Notice of Allowability

09/869,493

HOOVER, ALAN ANDERSON

EXAMINER'S AMENDMENT

FIG. 5

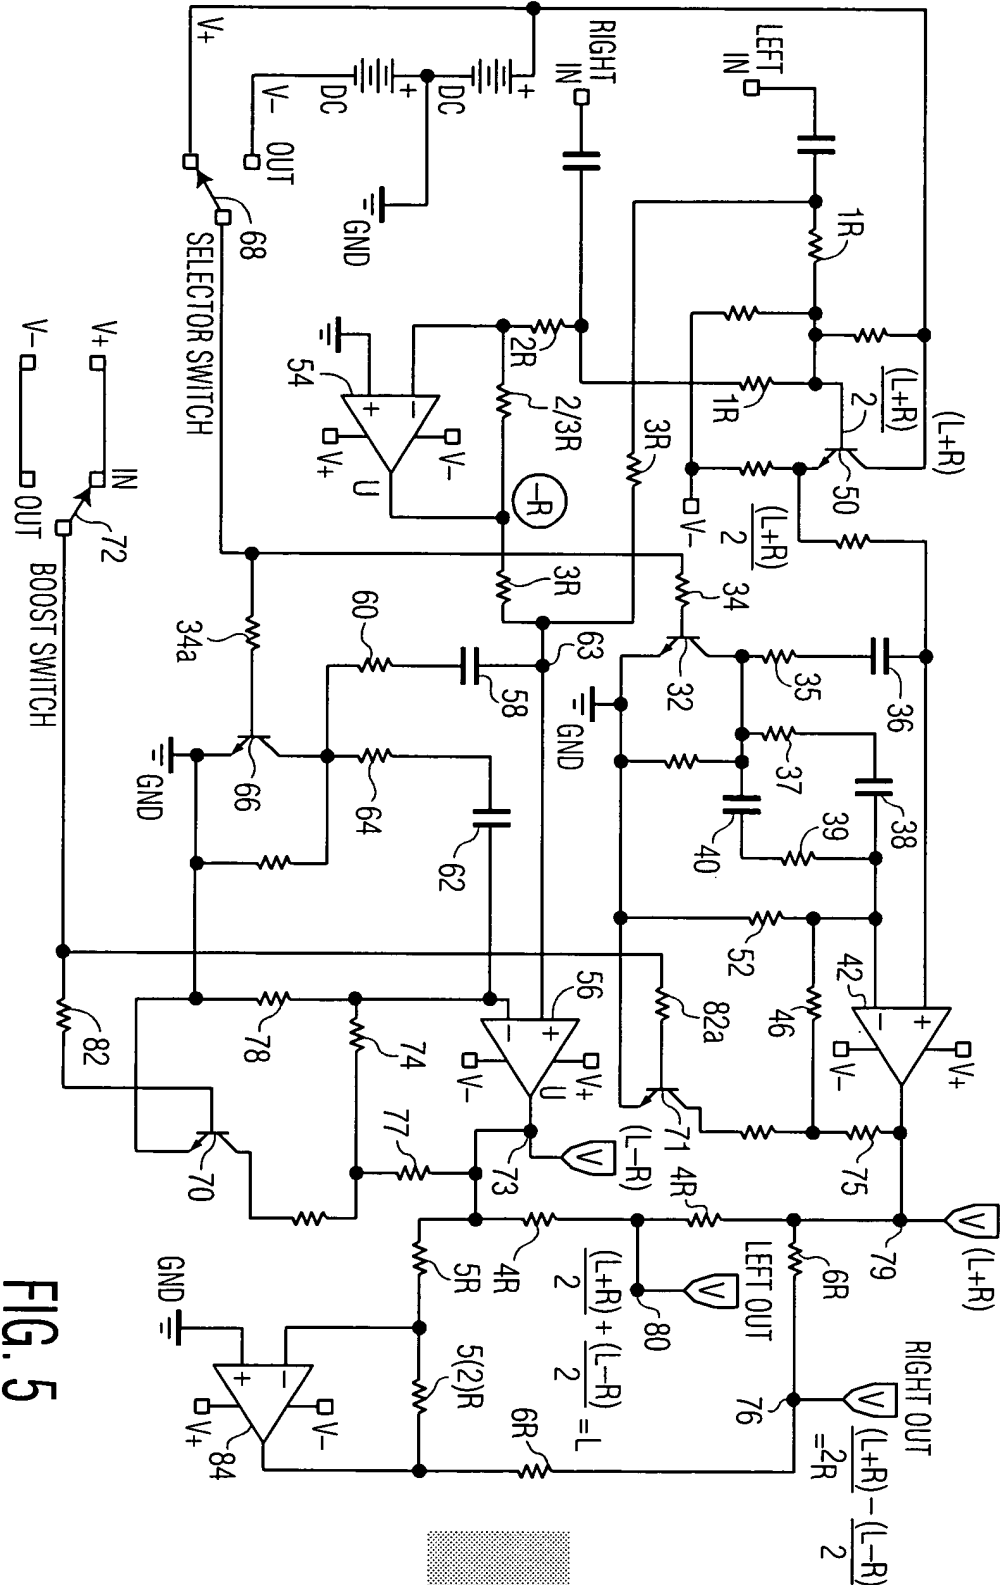
The attached sheet of drawing includes changes to Fig. 5. In Fig. 5, the reference numeral for the resistor connected to the base of the transistor 71 has been changed to 82a, the reference numeral for the resistor connecting the output of the opamp 42 to a terminal of the resistor 46 has been changed to 75, the reference numeral for the resistor connecting the output of the opamp 56 to a terminal of the resistor 74 has been changed to 77, the reference numeral for the node at the output of the opamp 42 has been changed to 79, and the reference numeral of the opamp 74 has been changed to 84.

Fig. 5 has been replaced by attached Fig. 5.
